**July 19, 2024**

**City of Alexandria Planning and Zoning Commission**  
Staff Comments, Findings, and Recommendations

Case: PZ-24-023  
Applicant: JEFFREY R. ANDERSON REAL ESTATE, INC.  
Location: SOUTHWEST CORNER MAIN STREET AND US 27 (999-99-26-066.00)  
Request: APPROVAL OF SITE DEVELOPMENT PLAN FOR A GAS STATION AND CONVENIENCE STORE

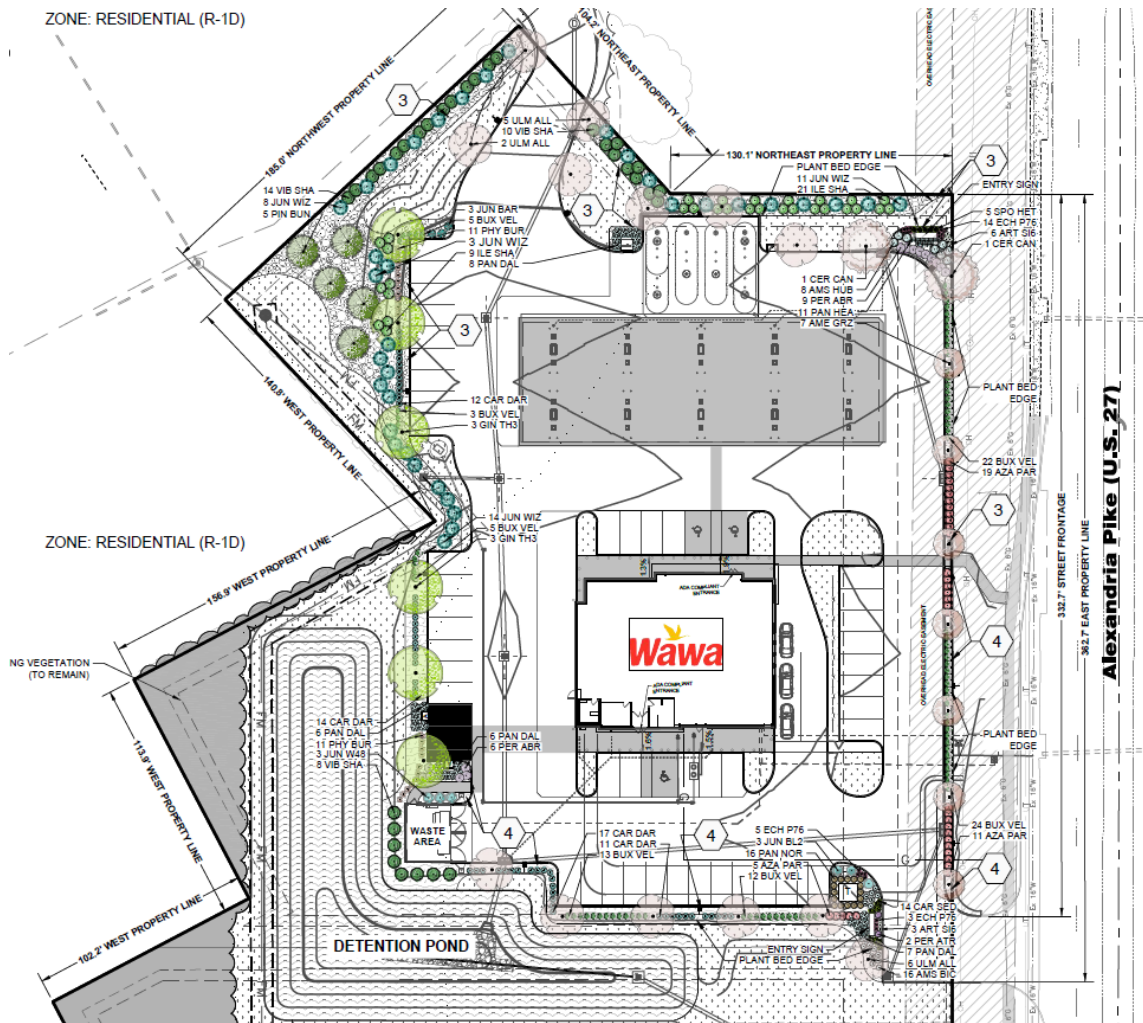
Based upon the volume of traffic generated by the development and the amount of traffic forecasted for the year 2034, there will be an impact to the existing highway network but the intersections will operate an acceptable level of service.

A right-turn lane will be required at the entrance on Alexandria Pike, US 27.

The signal timing for the A.M. peak hours should be monitored to determine if it is appropriate to add green time for KY 10.

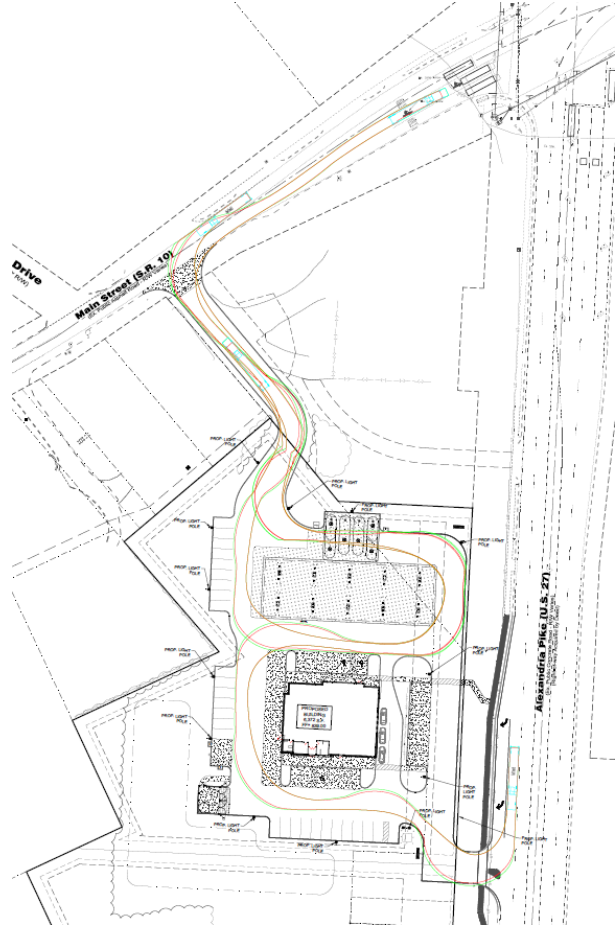
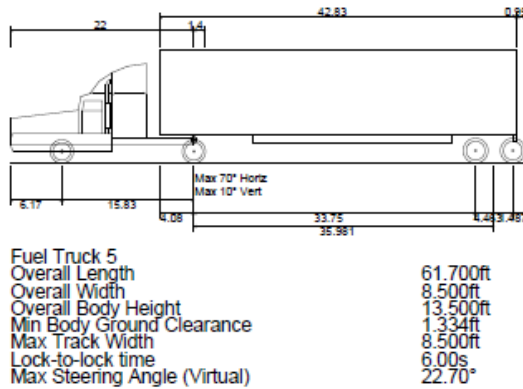
- P. A turning analysis was completed based upon the length of a fuel truck. Concern was expressed regarding an encroach slightly into the City Building parking lot. As requested, these plans were revised to increase this curb radius from 25ft to 35ft to reduce utilization of West Main Street for larger vehicles using the access.

The City Engineer noted that, the turning movement exhibit provided shows that a southbound fuel truck would need to turn from the through lane to turn into the site at the US 27 access point. The turning movement also requires that the vehicle drive over the raised median. Based on these facts, it is likely that larger vehicle such as the fueling trucks and emergency vehicles would enter from the full access point on W. Main Street (KY 10). However, the raised median should be of sufficient thickness to allow for these large vehicles to travel across without immediately breaking. A detail of the raised median should be provided.

*As noted above, the raised median is to be constructed per KYTC Type 1 mountable median.*

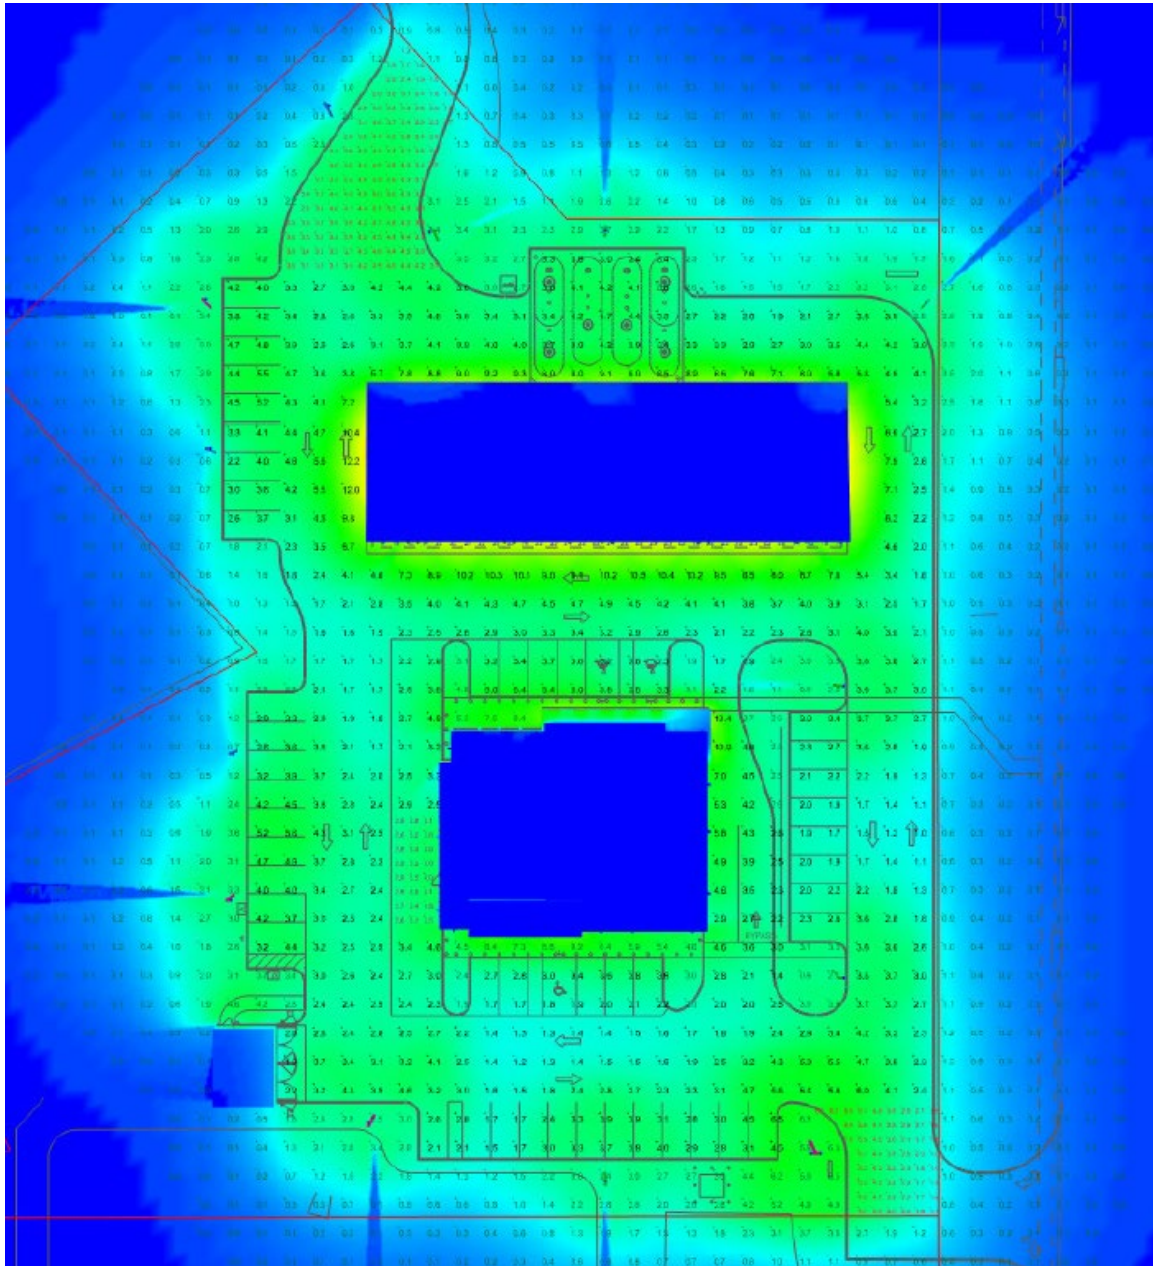
T. A lighting plan has been provided. We note that the site will be well lit. Concern regarding light from the site shining onto surrounding residential properties was noted to the applicants engineer.

The proposed LED light typically provides more directionally directed lighting. Revisions were made to help reduce the amount of light being directed to the

residential property. The light along the eastern edge that shined west towards the residential properties were relocated to inner median locations and turn to shine towards the east. While these lights were the farthest away from the residential properties, the modification should provide some benefit.
